Steven H. Emerman, Ph.D.¹
Testimony before House Natural Resources Subcommittee on
Indigenous Peoples of the United States
Hearing on “The Irreparable Environmental and Cultural Impacts
of the Proposed Resolution Copper Mining Operation”
Thursday, March 12, 2020

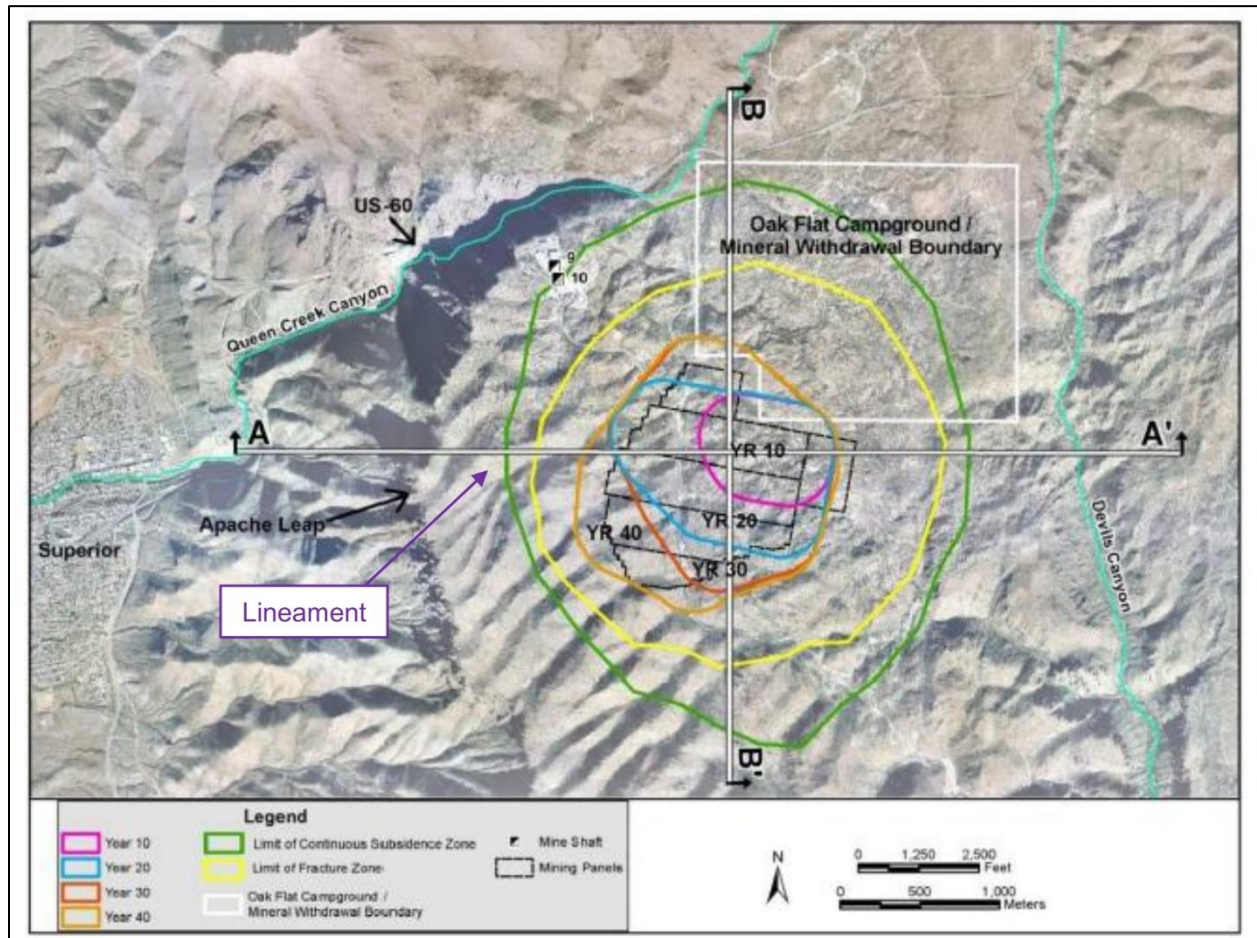
The actual data that were used in the subsidence modeling are not presented in any documents that have been provided by Rio Tinto. On that basis, there is no way for anyone not affiliated with Rio Tinto to repeat the subsidence modeling or to carry out his or her own subsidence modeling. Even the description of the data is inadequate for assessing the validity of the subsidence modeling. The most important information that is missing are the numbers of drill cores and the depths of the drill cores. The only exception to the lack of input data is the map of the geological faults that were used in the subsidence modeling (see Fig. 5). The primary control on the ability of block caving to transmit deformation to Apache Leap should be any faults that connect Apache Leap to the surface footprint of the block caving area, so that the most important fault is the West Boundary Fault (compare Figs. 3 and 5).

The predictions of the limits of the caved rock, fractured and continuous subsidence zones contain no uncertainties or error bounds of any kind (see Figs. 2-3). Presumably, all predictions are simply the best estimates and not the worst-case scenarios. The only exception to the lack of error bounds in subsidence predictions are the predicted maximum depth of the crater above the ore body. According to the DEIS (USDA, 2019), the maximum depth is projected to range between 800 and 1115 feet in depth. The above range of depths could be re-expressed as a predicted depth of 957.5 ± 157.5 feet. If the uncertainty (157.5 feet) is assumed to be the

Based on the uncertainty in the maximum crater depth, the uncertainty in the prediction of the approach of the subsidence zone to Apache Leap can also be assessed. Based on Fig. 3, the predicted distance from the center of the ore body to the outer limit of the subsidence zone in the direction of Apache Leap is 5035 feet. Assuming a coefficient of variation of 16.4%, the standard deviation of that prediction is 828 feet. Since the closest approach of the subsidence zone to Apache Leap is 1115 feet (USDA, 2019), the distance between the eastern edge of Apache Leap and the center of the ore body is 6150 feet. Then assuming that the population of predictions of the distance of the outer edge of the subsidence zone from the center of the ore body follows a normal distribution with mean equal to 5035 feet and standard deviation equal to 828 feet, the probability that the outer limit of the subsidence zone will extend onto Apache Leap or beyond is 8.9%.

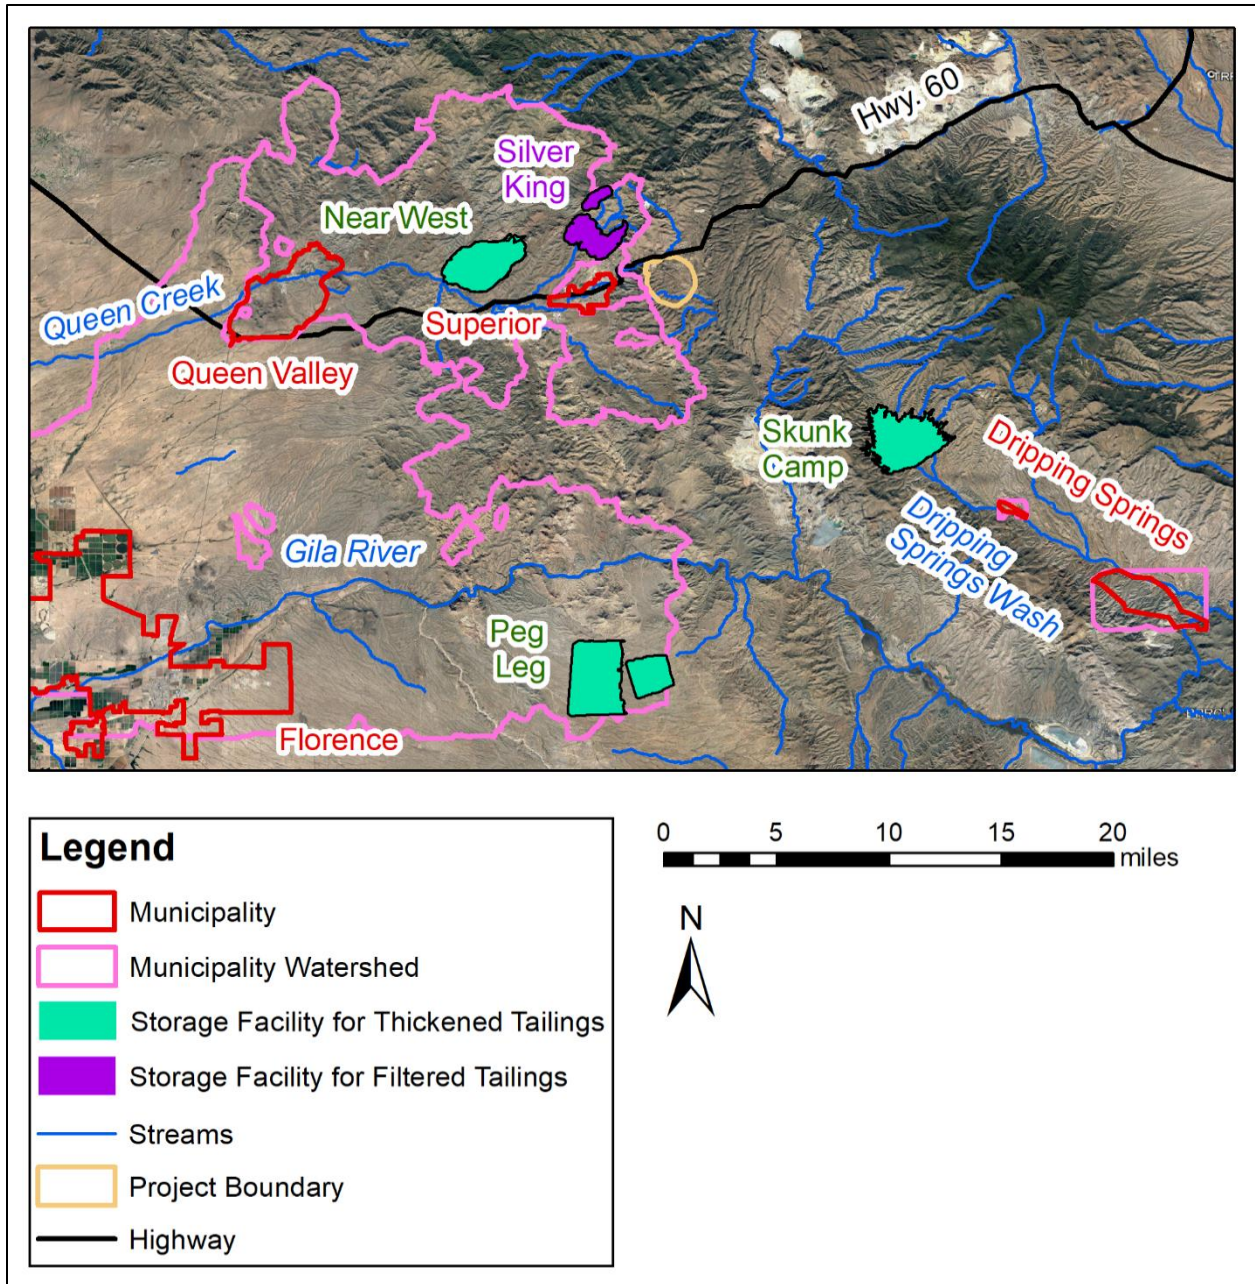
All of the local population centers include at least one proposed tailings dam in its watershed, so that the failure of each of the five alternatives has the potential to result in the loss of human life. It has already been shown that the predicted runouts are so large that the ability of a tailings spill to reach the above-mentioned local population centers is not a factor. The watershed of Superior includes the Silver King site at a minimum distance of 2500 feet (see Fig. 4). Even a slump of filtered tailings with no added water would nearly cover the entire town of Superior. The unincorporated area of Queen Valley would be impacted by the failures of either

of the Near West facilities (minimum distance 19,000 feet) or of the Silver King facility (minimum distance 8.2 miles; see Fig. 4). The town of Florence would be impacted by the failures of the Peg Leg facility (minimum distance 10.3 miles), either of the Near West facilities (minimum distance 16.0 miles), or the Silver King facility (minimum distance 20.5 miles; see Fig. 2). Based on the Digital Elevation Models (DEMs), the watershed of Dripping Springs does not include the Skunk Camp facility. However, Dripping Springs sits on the bank of Dripping Springs Wash, which would be quite likely to overflow following a tailings spill from the Skunk Camp site, a minimum distance of 17,000 feet from Dripping Springs (see Fig. 4).

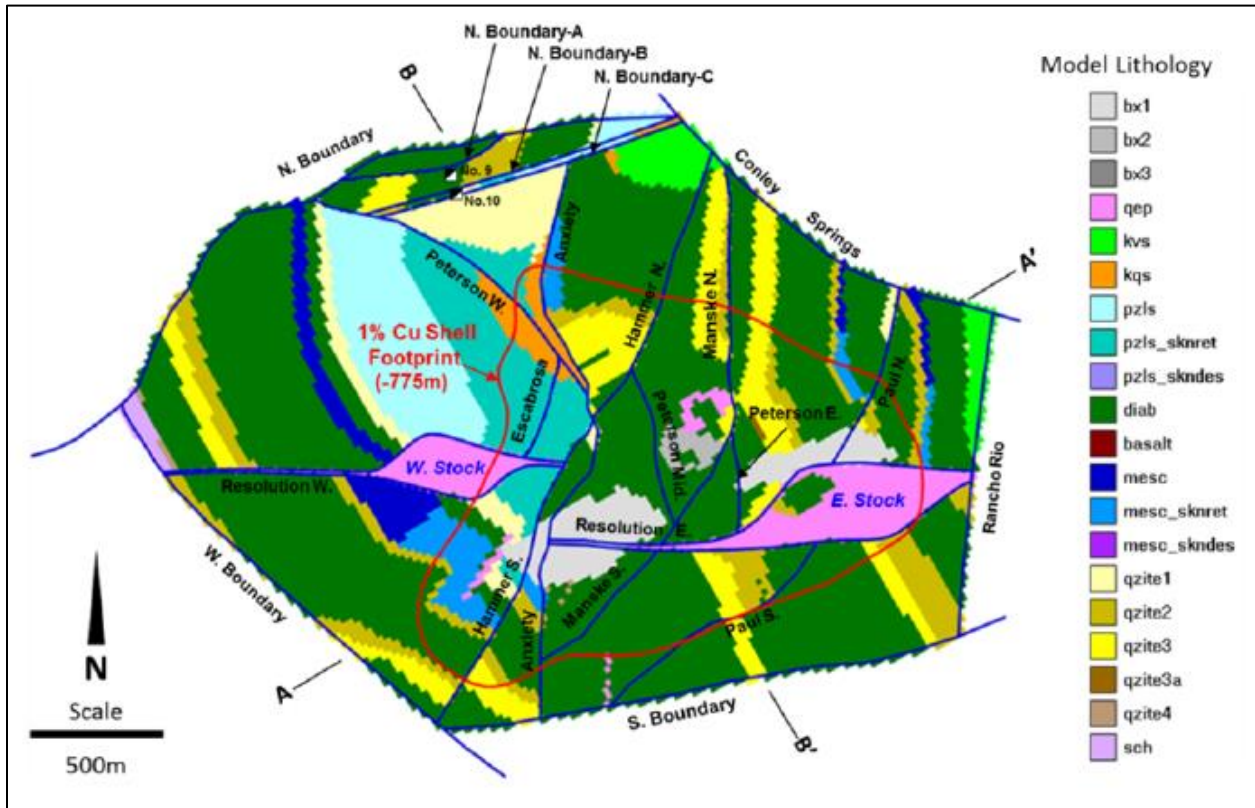
The superposition of the West Boundary Fault (as mapped in Fig. 5) onto a Google Earth image shows a pronounced lineament that is subparallel to the West Boundary Fault and offset from the fault by about 2000 feet (see Fig. 6). The nearly-parallel orientations of the West Boundary Fault and the lineament are certainly suggestive that the West Boundary Fault has been incorrectly mapped, and there is no other mapped fault that could correspond to the lineament (see Figs. 5-6). Unlike the mapped West Boundary Fault, the lineament intersects the caved rock zone (see Fig. 3), so that there is potential for deformation to be transmitted from the caved rock zone to Apache Leap. On this basis, there could have been an underestimation of the extent of the subsidence zone.
